Addendum No.: 2

Date Of Addendum: May 2, 2018

MacDougall Walker Correctional Institution
MacDougall Garage Repair/Rehabilitation
1153 East Street South
Suffield, CT
BI – JA-469

1 STAIR #1 SECTION
 A4.2 0 4' 8'
 SCALE: 3/8" = 1'-0"

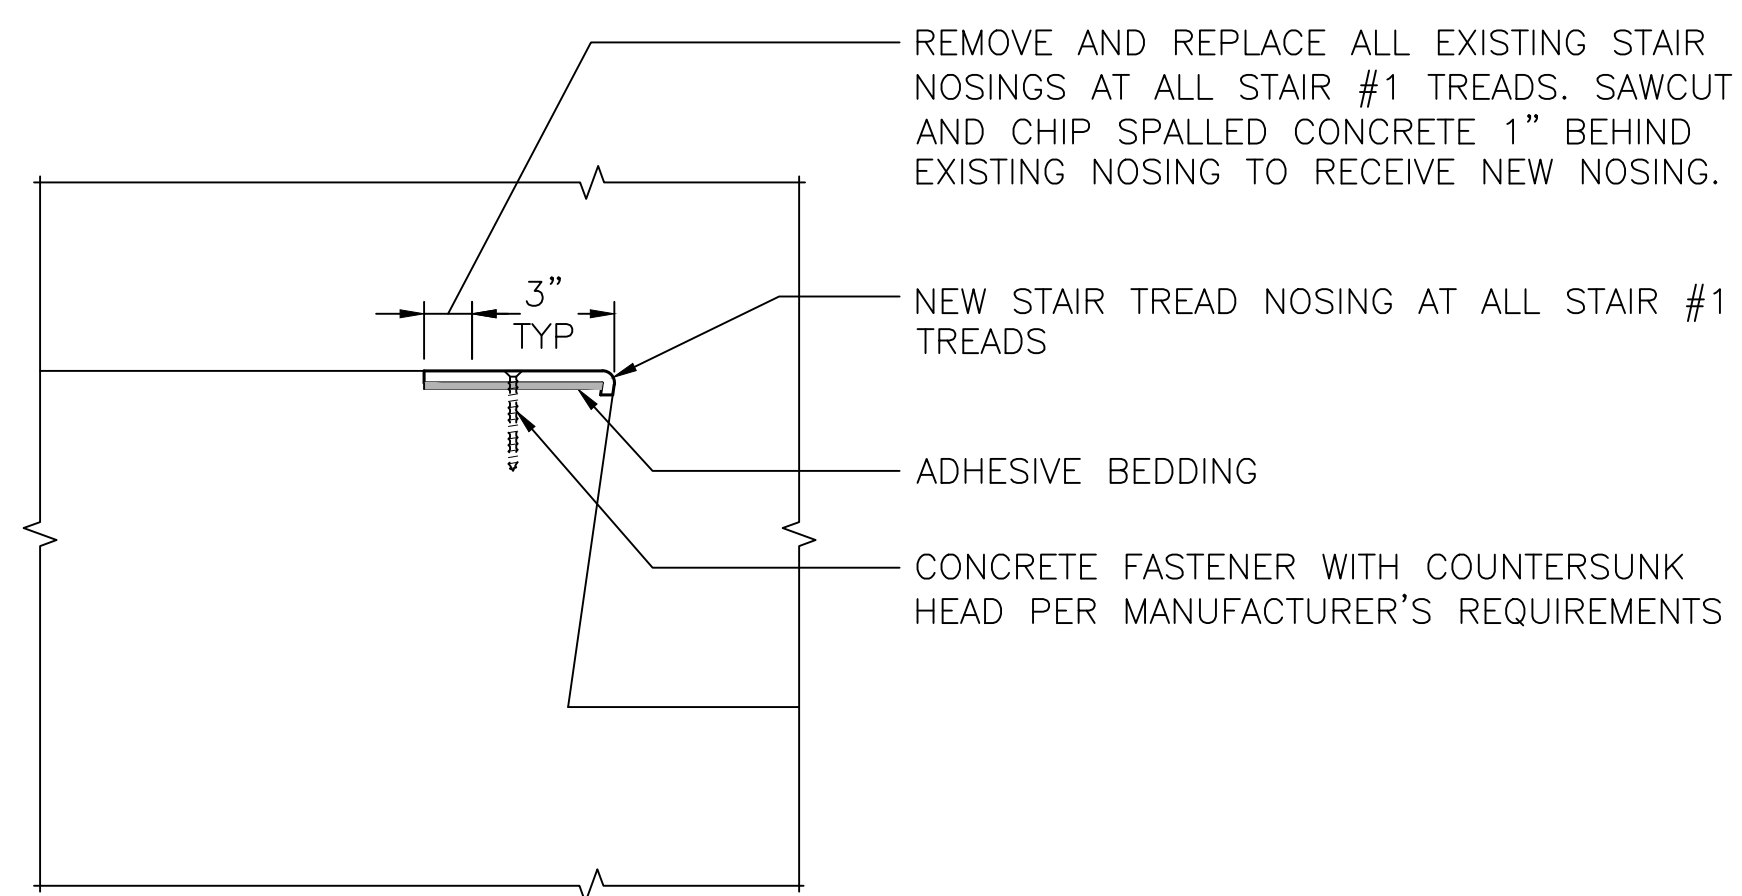
DESCRIPTION: The handrail at the top landing has been eliminated and a handrail extension in the direction of travel at the top of the stairs has been added.

2 STAIR #2 SECTION
 A4.2 0 4' 8'
 SCALE: 3/8" = 1'-0"

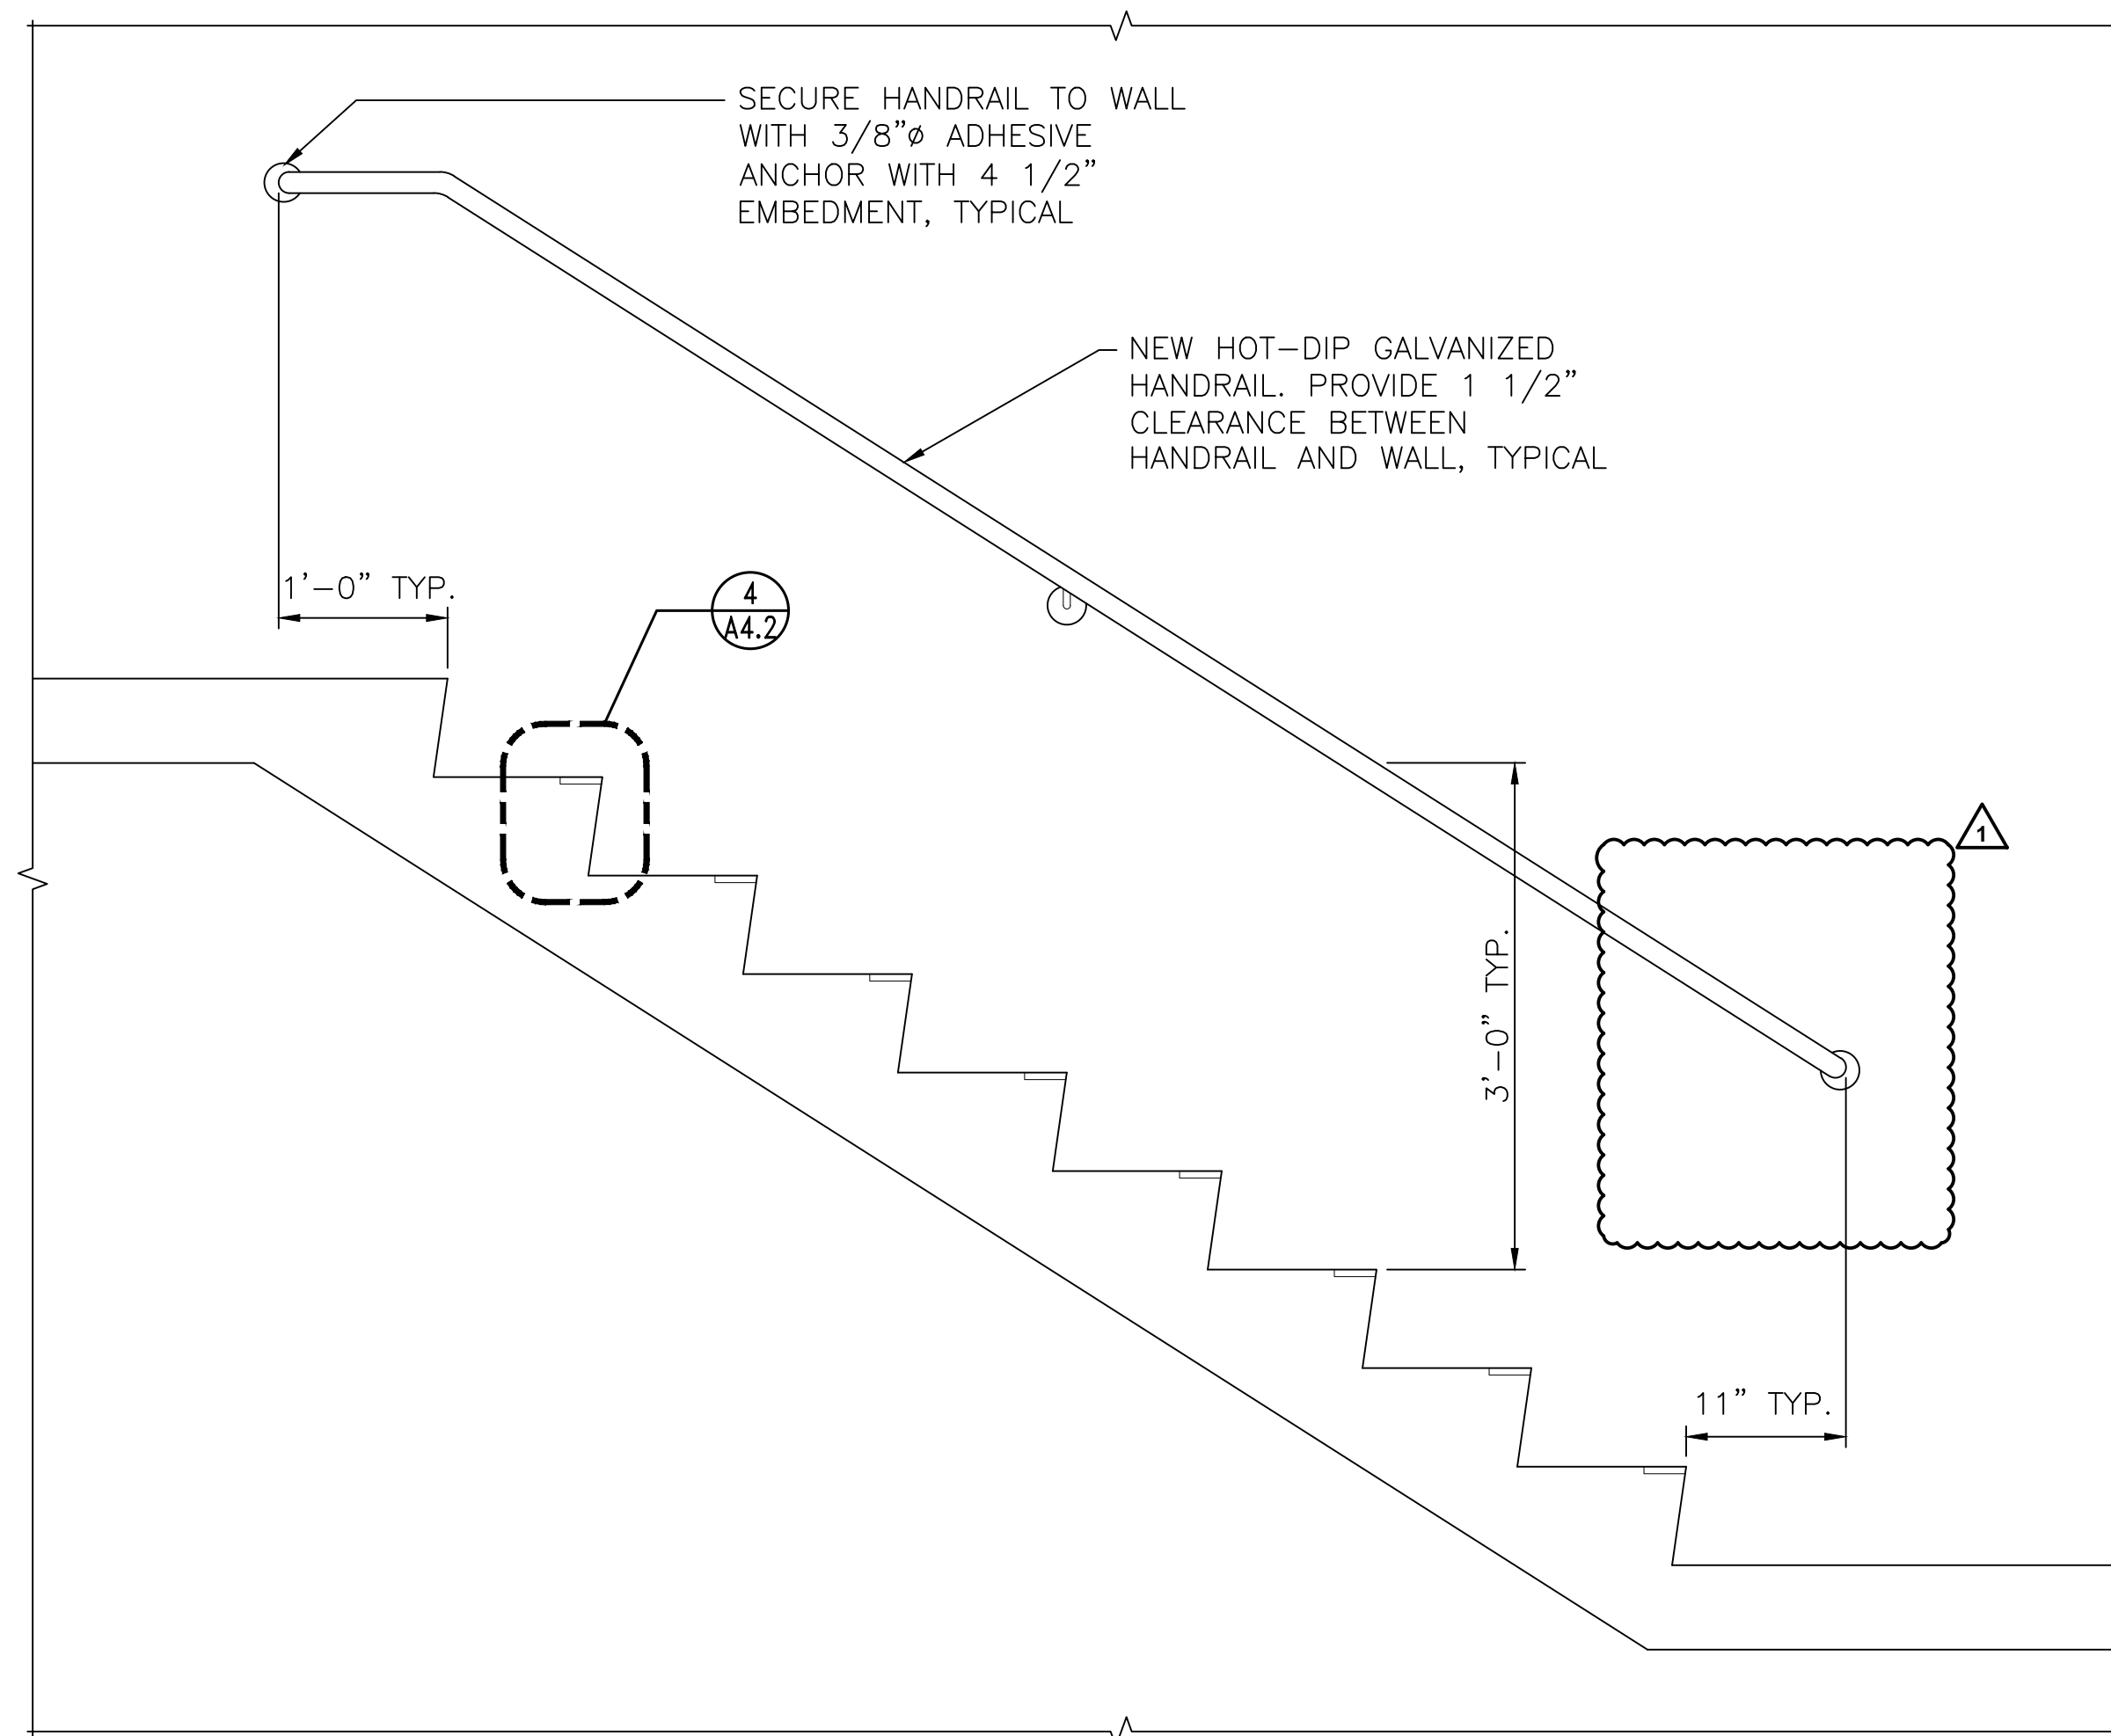
DESCRIPTION: The handrail at the top landing has been eliminated and handrail extension in the direction of travel at the top of the stairs has been added.

5 TYPICAL WALL ELEVATION AT HANDRAIL
 A4.2 0 6" 1' 2' 4'
 SCALE: 1" = 1'-0"

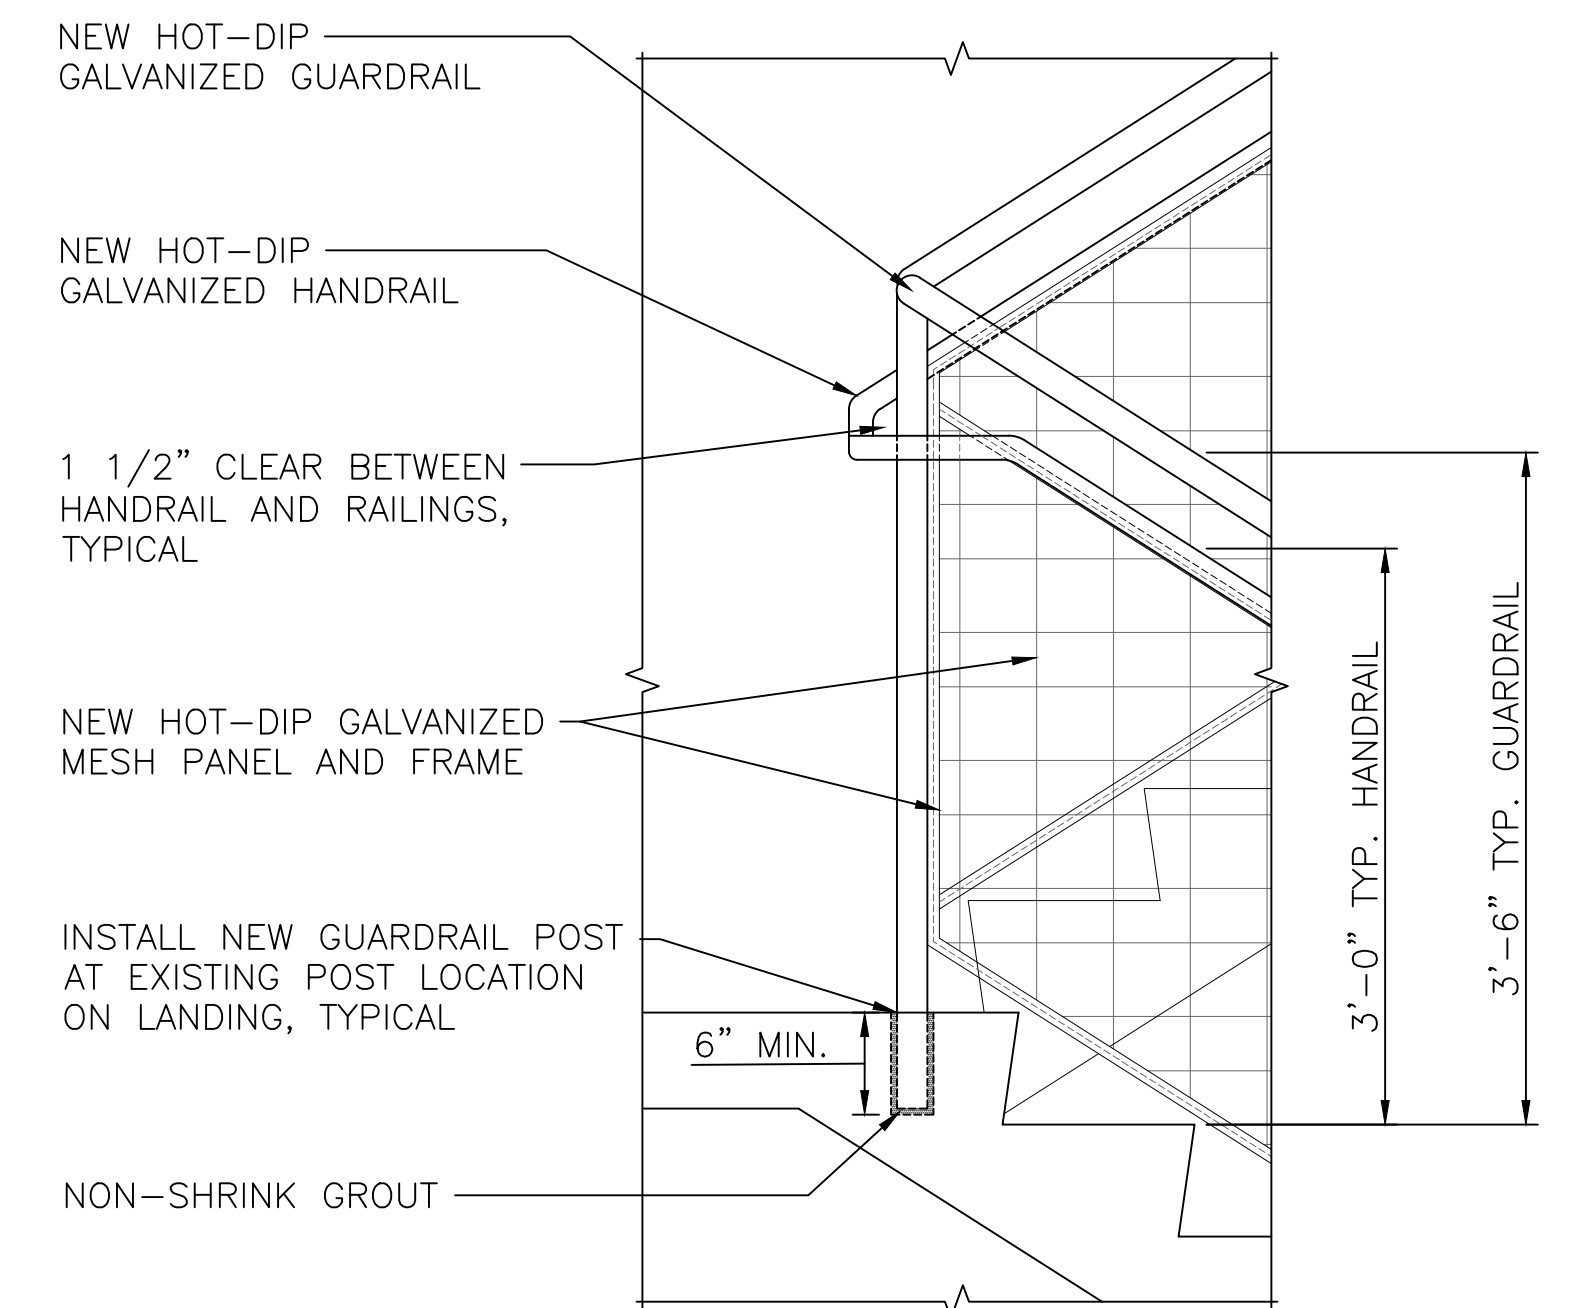
DESCRIPTION: The handrail at the bottom of stairs was revised to extend 11" sloped past the face of the bottom tread. This is typical at all bottom tread locations at all stairs.
